A recording of the Local Meeting can be viewed here: <https://vimeo.com/444938735/dab360182c>

Questions and comments raised during the meeting

Sydenham Hill - path network and gradients diagram

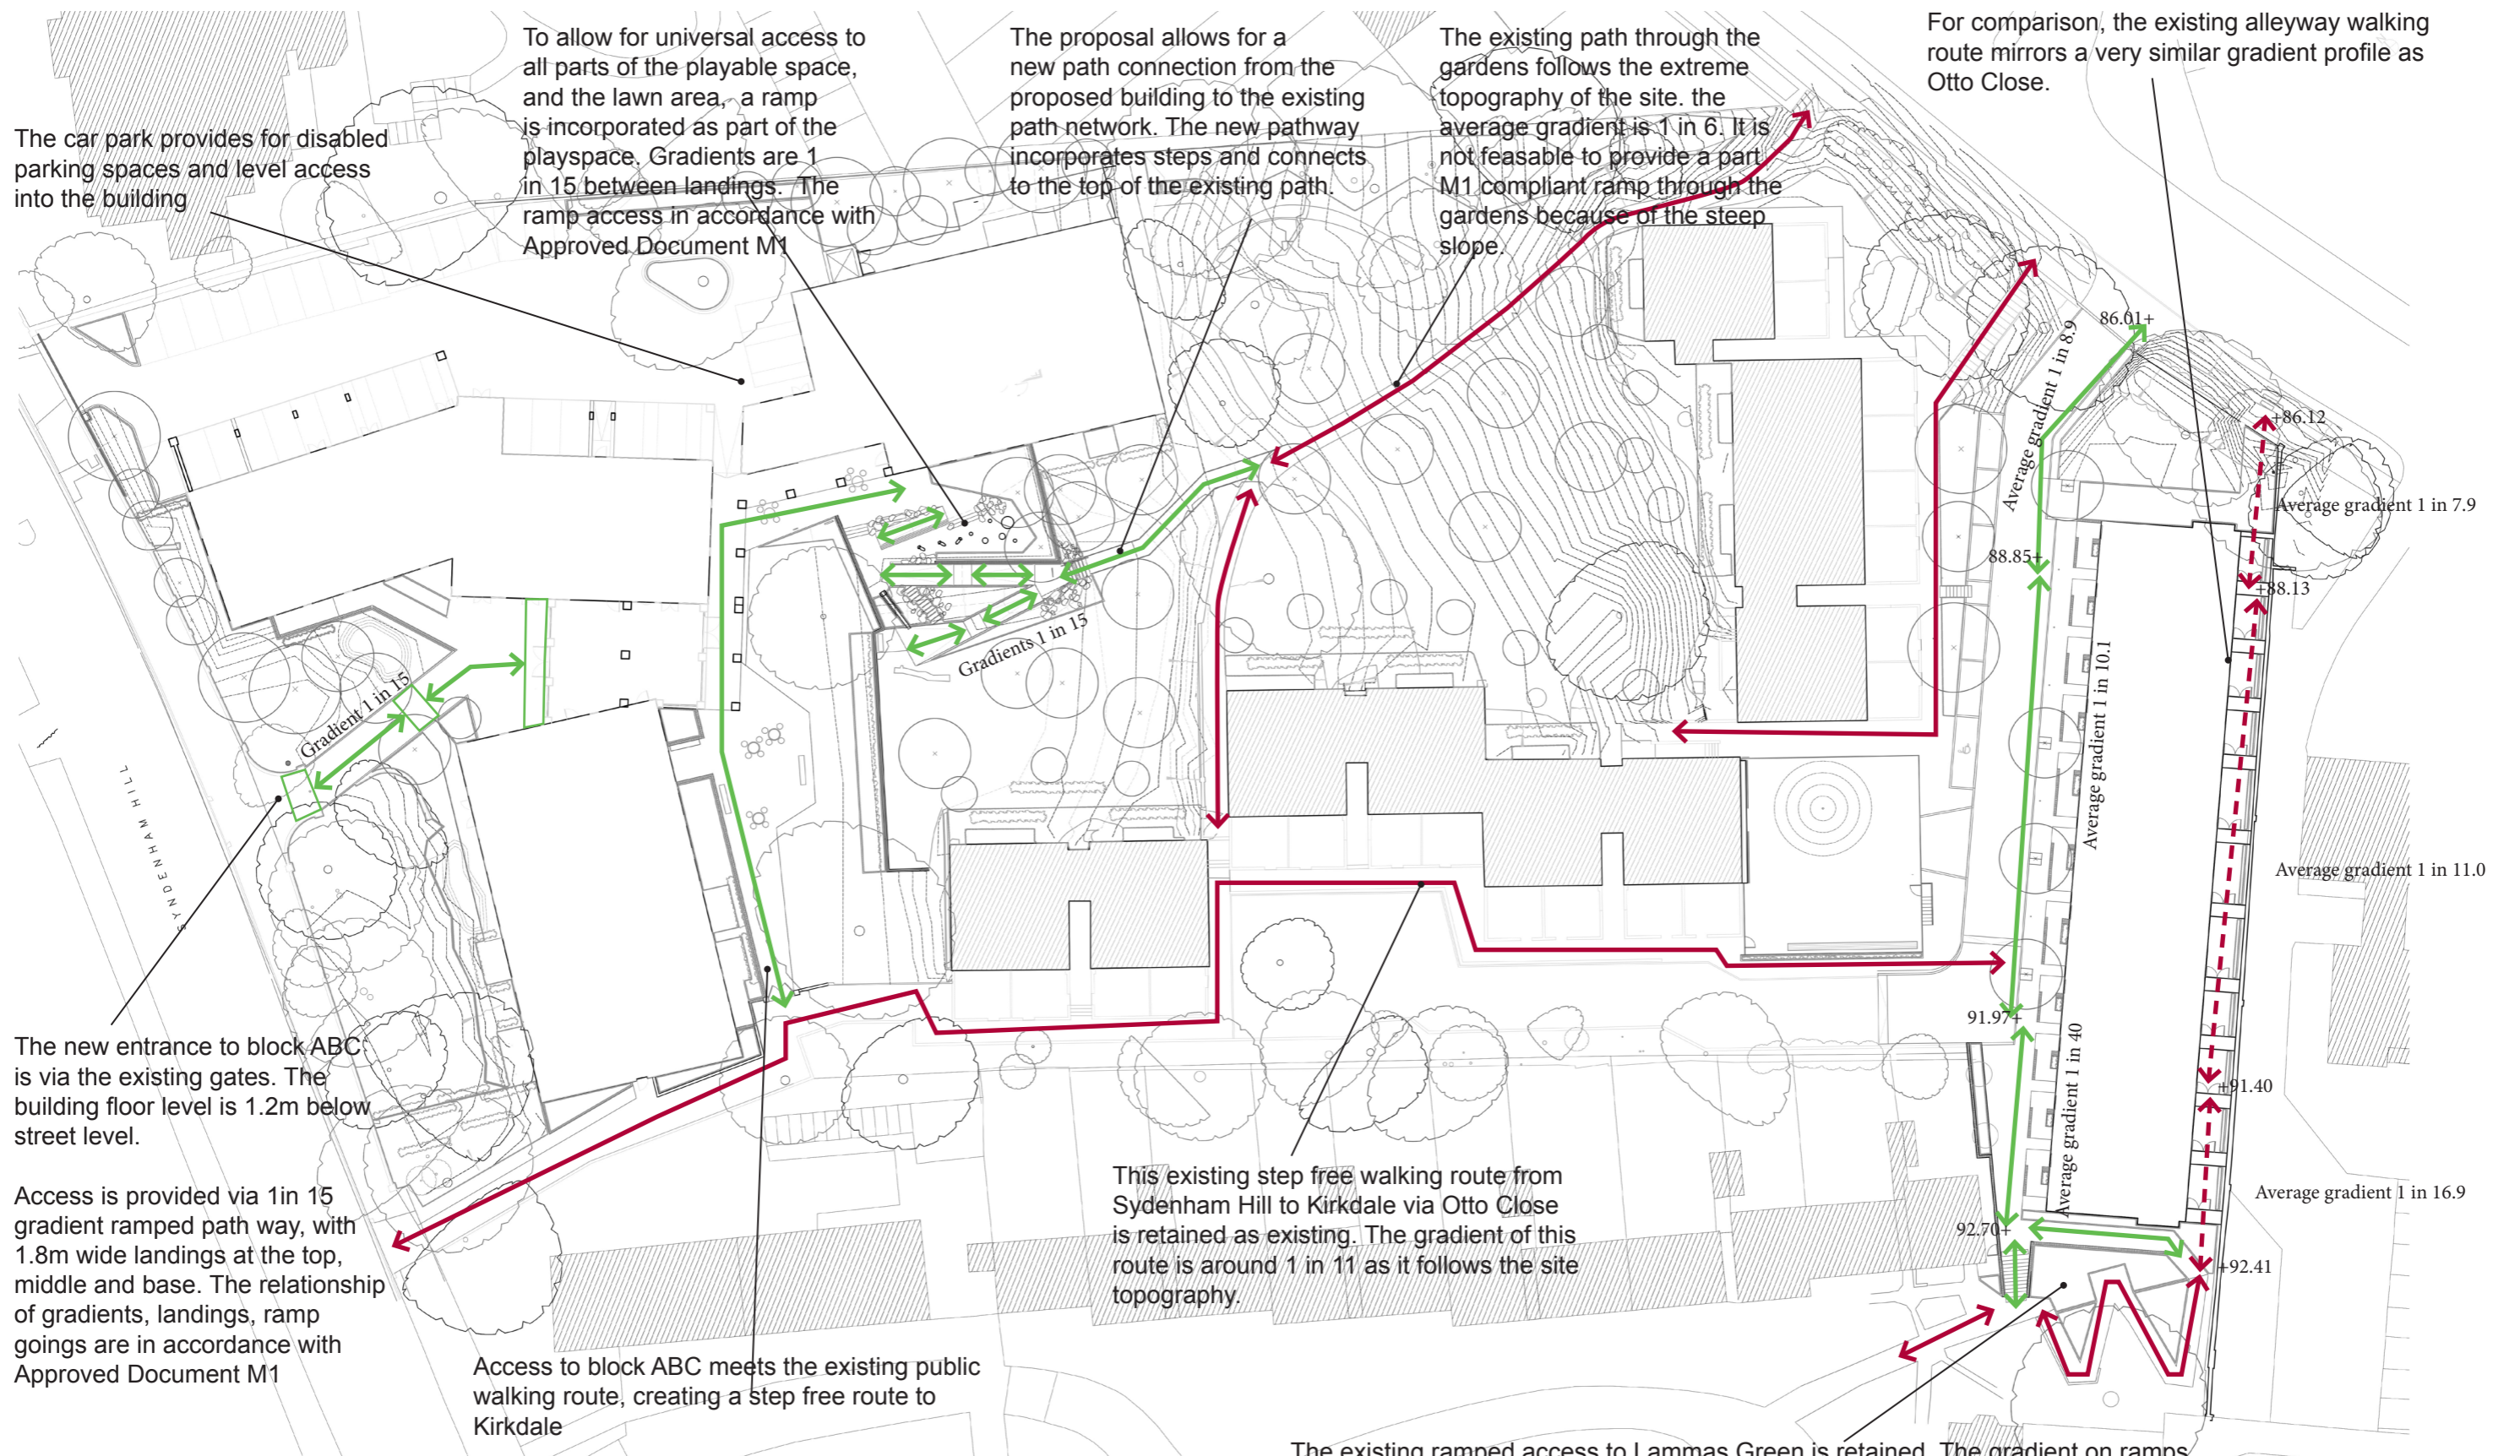
<u>Comment</u>	<u>Answer</u>
145.	Very concerned that no knowledge of steepest gradients of step free access to Kirkdale high street and shops. As the applicant has failed to give steepest gradient to properties nearest to Sydenham Hill to access Kirkdale, what a) is the steepest gradient to access Sydenham Hill via the public footway on Kirkdale? b) what disability impact assessment has been made for residents nearest to Sydenham Hill to access Kirkdale and local shops?	<p>The hillside topography of the estate makes movement routes very challenging for wheelchair users. At present the step free access route between Kirkdale and Sydenham Hill follows the alleyway, cuts through the garages and moves along Otto Close west boundary, to meet Sydenham Hill next the entrance to Lammas Green. There is a second route through the community gardens, which is extremely steep and has steps at one end.</p> <p>The proposed building ABC connects into this existing network. Residents from the new block can access the step free route along the western boundary on Otto Close which descends down to Kirkdale. The gradient of this existing route is determined by the site topography and is on average a gradient of 1 in 11. There are no level landings on this existing route.</p>

146.	<p>I have not received a reply to the following question: What is the gradient at the steepest section for the step free access path from Kirkdale road to access the properties at the top of the development (nearest to Sydenham Hill), and, what length of footway slopes are there between level resting platforms required by manual wheelchair users to use?</p>	<p>See response to 145 and 147 and attached plan.</p>

242	<p>What is the gradient <u>at the steepest section</u> for the <u>step free</u> access from Kirkdale road to access the properties at the top of the development (nearest to Sydenham Hill), and, what length of footway slopes are there between <u>level resting platforms</u> required by manual wheelchair users to use?</p>	<p>Refer to response to qu.s 145-151 and attached plan. Accessibility requirements to the proposed building and across the estate have been fully considered.</p>
-----	--	---

<p>The questioner asks if the applicant has considered if it is possible to provide a more accessible step free route between Sydenham Hill and Kirkdale</p> <p>It is not possible to construct a shallower ramped route owing to the site condition. The possibility of constructing an alternative route through the gardens was considered by is also unachievable, given the existing slopes are steeper than 1 in 6. In order to provide a suitable ramp, the whole of the communal garden would need to be remodelled and given over to a 275m long ramp zig-zaging across the lawns.</p> <p>The proposed block ABC is accessed from Sydenham Hill via the existing entrance gates. The floor level of the building is determined by existing tree levels, and is 1.2m below the street level [matching Mais House] A 1 in 15 gradient ramp path allows access to the entrance lobby. The ramp route includes landings at top middle and base.</p> <p>Th access the middle lawn from block ABC, and new ramped route is provided.</p> <p>A further linking footpath connects to the existing path through the communal gardens. This route includes steps, and is an alternative to the step free route to Kirkdale described above.</p> <p>Please see accompanying path network diagram for more details</p>

147.	<p>has Tim been to the site? The footpath is being moved by several metres so it will change the gradient of the path</p>	<p>The ramped access via the alleyway, the ramps onto Lammas Green and the gradients of the path network generally have been carefully considered. Additional site survey work was undertaken to ensure the levels information was correct and complete.</p> <p>Whilst it is acknowledged that the existing alleyway is a well-used and important route in the estate, the wider plan to provide social homes on the garage site required a rethink of how access could be provided. There was strong guidance given by the Police Secure By Design advisor against</p>
